April 12, 2018
Staff Report to the Southeast Town
Design Review Committee

CASE #MPL2018-10012
Item #4

UCF MEDICAL HOSPITAL AT LAKE NONA

PROPOSED SITE PLAN

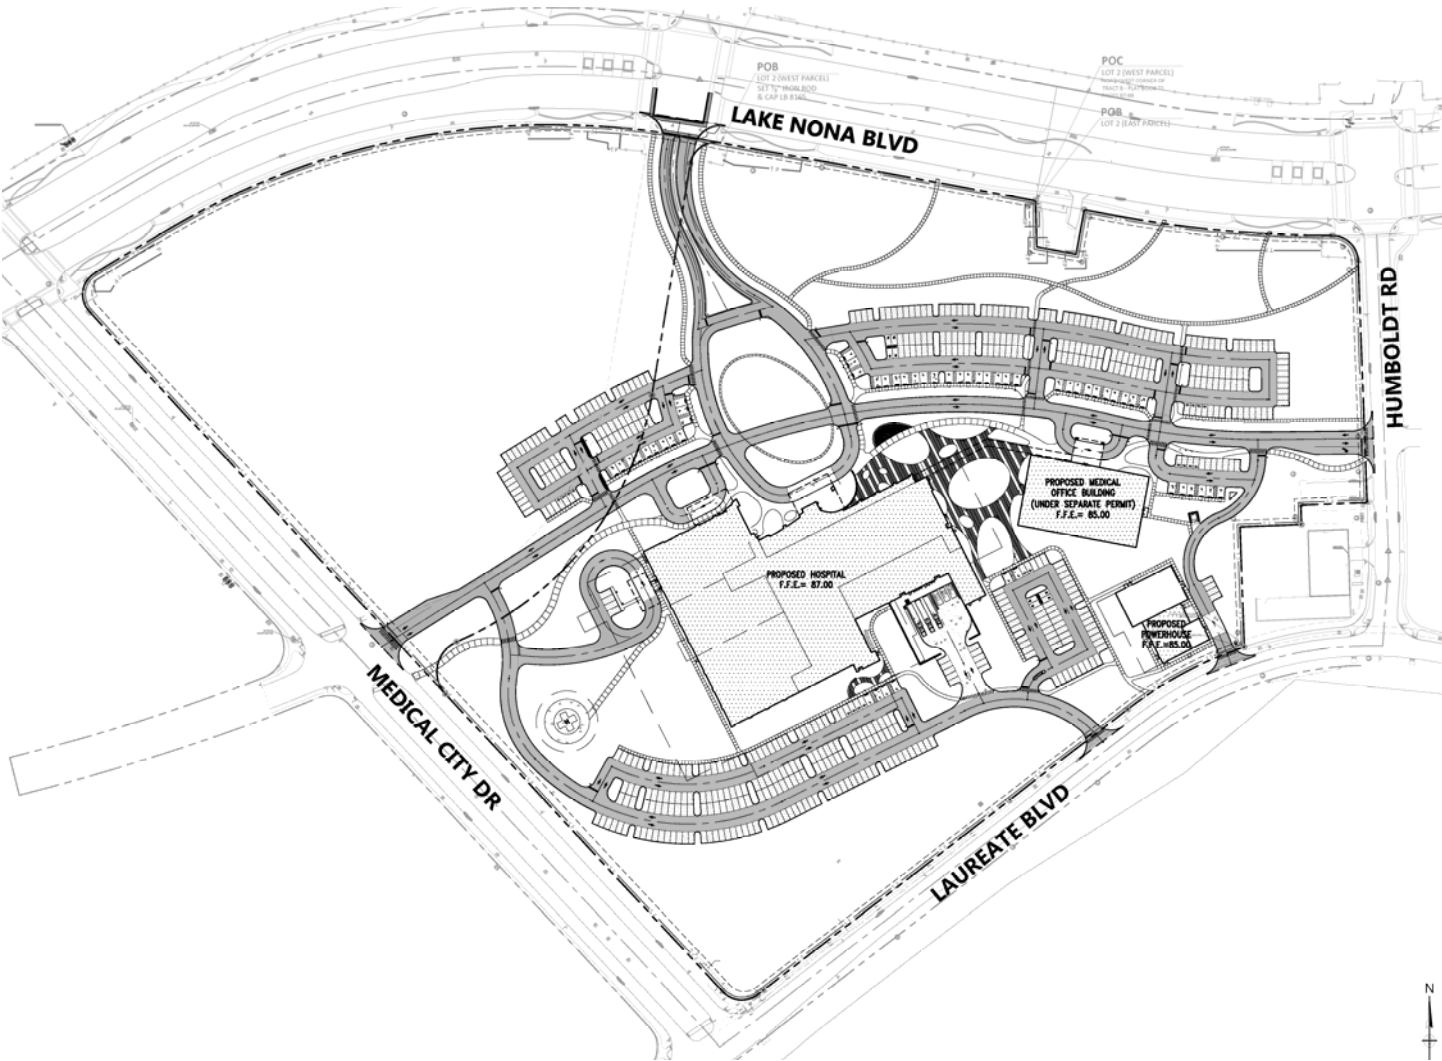
The site plan depicts a helipad on the western side of the property. According to Chapter 8, Section 8.21 of the City Code provides classification of heliports. A "Type B heliport" is a heliport operated by a hospital or air ambulance service under a permit issued by the City and used primarily by helicopters operated by such hospital or air ambulance service for the transportation of sick or injured persons, medical personnel, and medical supplies; Type B heliports may not be used for the loading or unloading of passengers, baggage or freight carried for hire and no charge may be made or paid for the use thereof.

The proposal for the hospital depicts driveways through the site which will provide the good connectivity that Sanger Road was planned to provide. After review of this site plan, the minor amendment to the Lake Nona Southern Circulation Plan to eliminate the requirement of Sanger Road extension through this property is approved.

3. *Driveway Separation*
The 2 driveways onto Laureate Boulevard must be separated by a minimum of 125 feet to meet City Code requirements.
4. *Internal Vehicular Drives*
Developer should consider the use of narrower internal drives to better control speeds. Raised crosswalks at appropriate locations could also be used as a speed control measure.

5. *Pedestrian Path*
A pedestrian path from the south portion of the building and parking lot to the sidewalk along Laureate Boulevard is required. The path must be a minimum of 5 feet wide, constructed of impervious material, and meet all ADA requirements.

ARCHITECTURAL ELEVATIONS

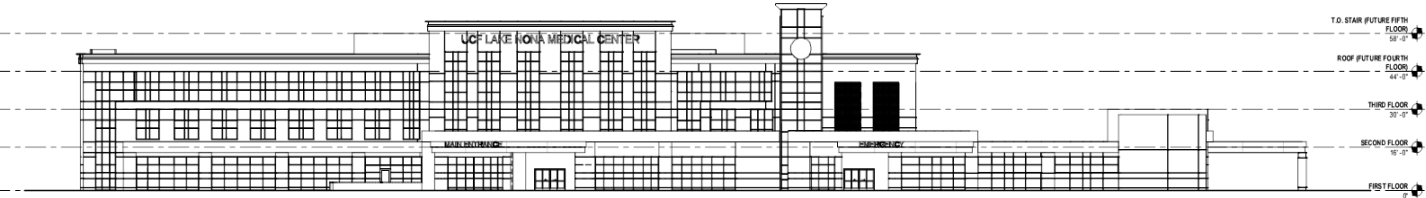
The proposed north elevation depicts a high-rise sign for the hospital. If the high-rise sign is illuminated at night, the text within the sign must be lit with white. All lighting must be internal back-lighting. The applicant has not provided signage details such as locations and height of monument signs or copy area of each sign, including the high-rise sign. Therefore, a master signage plan for this development is required prior to building permits. All signage shall be consistent with Chapter 64 of the LDC and Lake Nona Master Sign Plan.

26. No one particular style is dictated over another; however, architecture should be authentic to the style employed. Elevations for the medical office building and power house were not submitted. An appearance review letter of determination must be submitted for each per to permit submittal.
